Subject: SSI 9471 – Request for Modification (Appendix 1- Schedule of Land)

Infrastructure Approval (SSI 9471) provides consent for the development of the Port Kembla Gas Terminal. The Terms of Approval requires the development to be undertaken generally in accordance with Environmental Impact Statement (EIS) and in accordance with the conditions of the approval.

Figure 2: Final alignment of the Bunker Oil Line

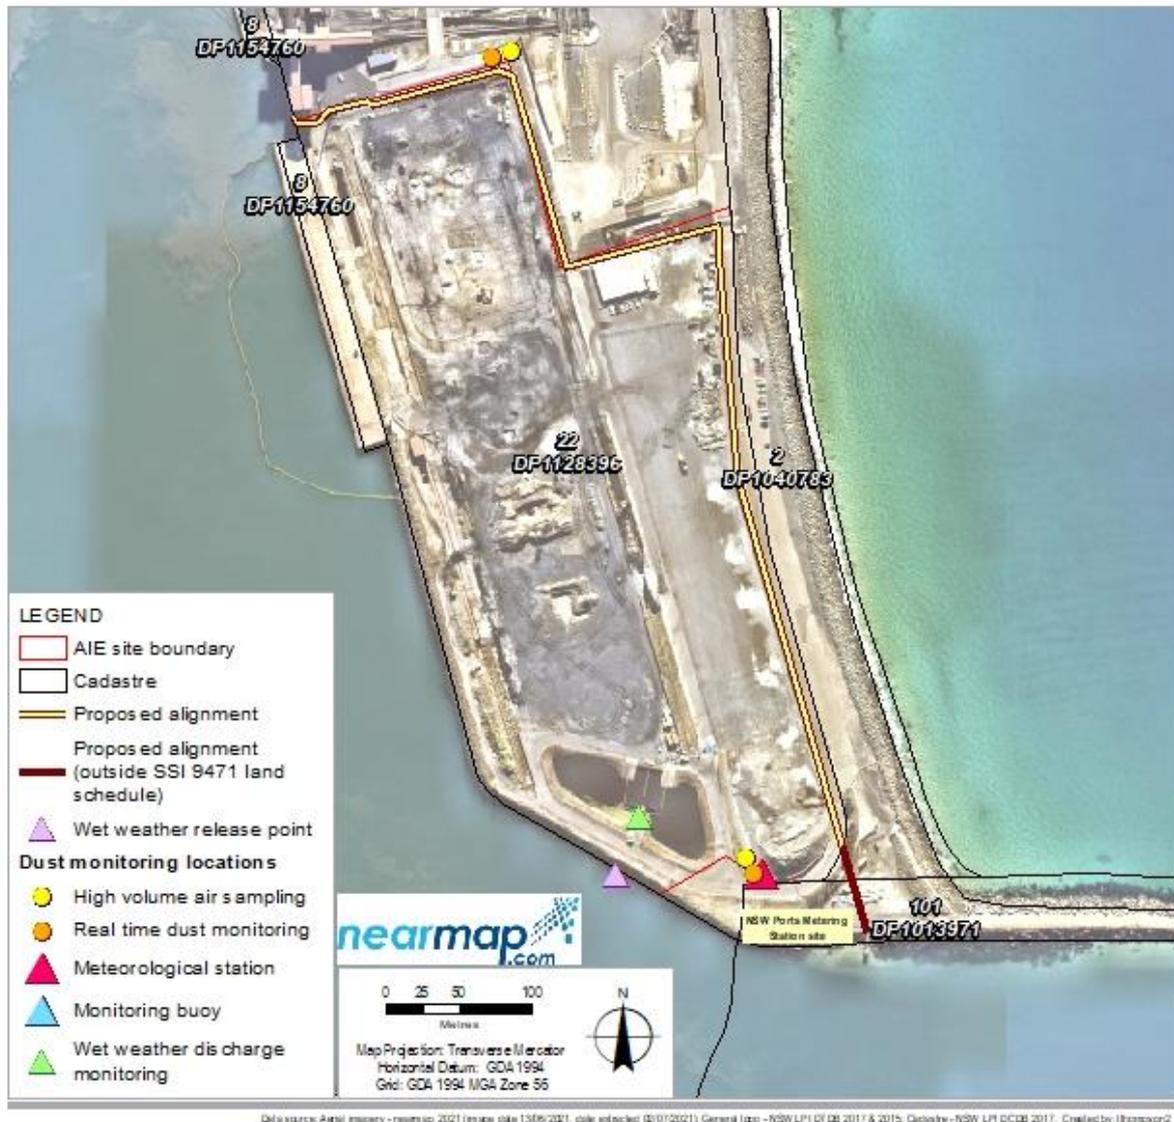
Following detailed engineering and construction planning, the route for the relocation of the Bunker Oil Pipeline has been finalised and differs from the indicative route proposed in the EIS at the southern end of the development.

The tie in point within the NSW Ports metering compound is located on Lot 101 DP 1013971. The pipeline traverses Road 8, NSW Ports land (Lot 2 DP 1040783) before running adjacent to the concrete retaining wall along the edge of Seawall Road within the AIE Lease Area (Lot 22 DP 1128396) as shown in figure 2 below.

The metering compound site (Lot 101 DP 1013971) and adjoining lot extending along the Coal Loader Seawall / Seawall Road (Lot 2 DP 1040783) lots are not listed in Appendix 1 - Schedule of Land and are therefore not land subject to the terms of the approval.

Update Appendix 1 – Schedule of Land to include Lot 101 (DP 1013971) and Lot 2 (DP 1040783) in the Berth 101 section of the Appendix.
